October 2020  
FL861AB  
NHTSA #20V-529

## Subject: FCCC Motorhome Valve Stem Stabilizers

**Models Affected: Specific Model Years 2017 - 2020 FCCC MC, XCL, XCM, XCR, and XCS chassis manufactured February 20, 2017, through August 15, 2020, and equipped with a valve stem extension and stabilizer configured with a specific tire valve stem and wheel combination.**

**Fig. 1, Valve Stem with Stabilizer**

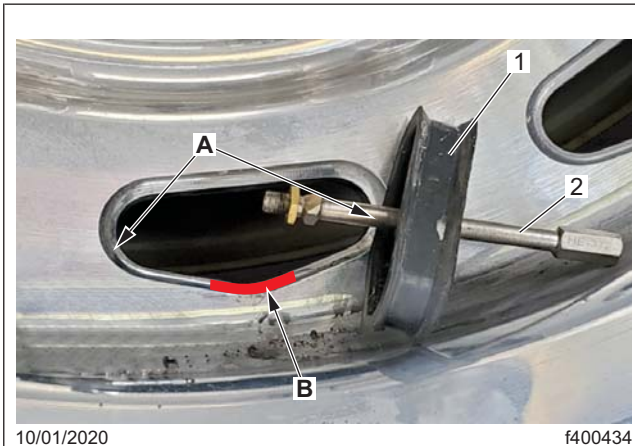
5. If the valve stem extension is rubbing the side of the wheel opening, shown in [Fig. 1](#), reference A, gently swivel the inner valve stem so that it aligns with the center of the wheel rim opening. The valve stem should swivel with little resistance.

6. If the inner-wheel valve stem extension is rubbing at the top of the wheel rim opening, shown in [Fig. 1](#), reference B, or if the valve stem stabilizer is dislodged, remove the stabilizer and inner-wheel valve stem extension. Slide a small diameter tube over the end of the valve stem, then gently adjust the angle of the inner-wheel valve stem by bending it so that it aligns with the center of the wheel rim opening. If adjusting the inner-wheel valve stem resolves the issue, go to step 10.

- A. If the valve stem extension is rubbing the side of the wheel rim opening, gently swivel the inner valve stem so that it aligns with the center of the wheel rim opening.
- B. If the inner-wheel valve stem extension is rubbing at the top of the wheel rim opening (shown here at the bottom of the wheel rim opening due to the rotation of the wheel in the photo), or if the valve stem stabilizer is dislodged, remove the stabilizer and inner valve stem extension.

If the bend requires more than a few degrees, replace the inner-wheel valve stem using part number 13-10027-000 (574-F29). See [Fig. 1](#) and [Fig. 2](#).

**Fig. 3, Radial Runout Check for Tires**

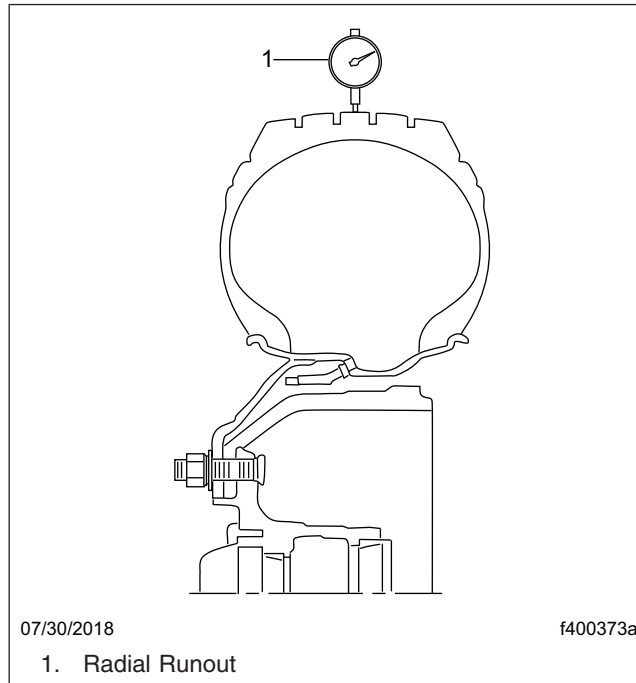
- Using a tire runout gauge, check the radial runout and record it for later use. See [Fig. 3](#).

- Remove the wheel and valve stem extension, then replace the valve stem.
- Using a tire runout gauge, measure and record the radial runout of the tire and wheel assembly. Mark the highest point on the tire and wheel assembly. Rotate the tire and wheel assembly until the high spot is at the 12 o'clock position (without allowing the assembly to turn). Loosen all lug nuts to let the assembly settle, then tighten the lug nuts in the proper sequence. See **Group 40** of the *Recreational Vehicle Maintenance Manual* for the tightening sequence. The radial runout should be very close to what was recorded earlier.

**Fig. 4,**

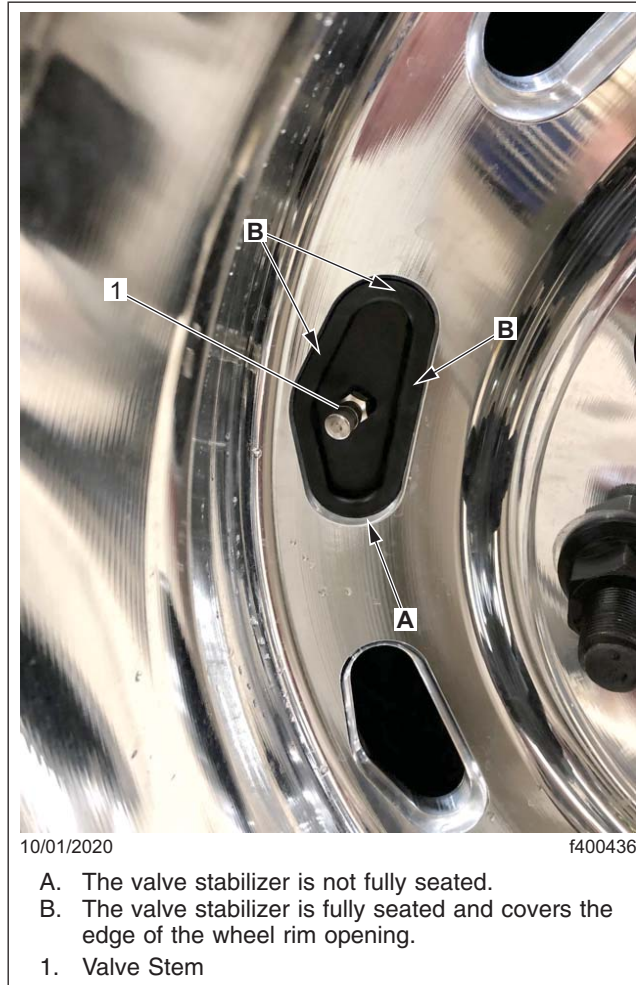
10. Install the valve stem extension and stabilizer. Spraying water around the outer lip of the stabilizer will make the installation easier. Ensure that the stabilizer is fully seated in the wheel rim opening. See **Fig. 4**.
